Council's reference: MISC/42/2010/D

State Significant Application No: MP10_0080-Mod-2

Myuna Coal Mine – Modification 2 including:

Council staff have reviewed the submitted Modification Report, prepared by EMM, dated 3 July 2020, and wish to raise the following issues:

Figure 1 – Road ownership

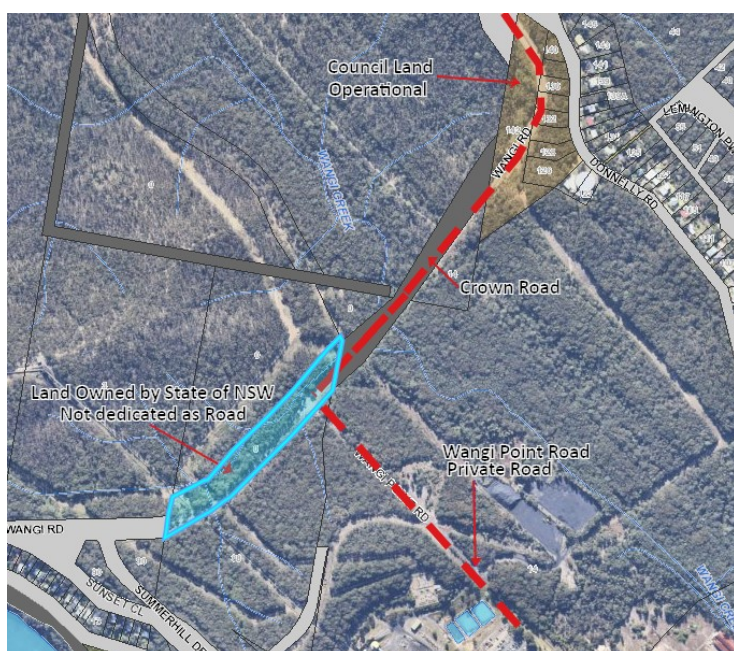
Wangi Road is under the care and control of TfNSW and their assessment is required. Crown Lands should also be consulted, as part of the route is over a Crown Road (Refer to Figure 1 below shaded dark grey and part over free hold land (shaded blue).
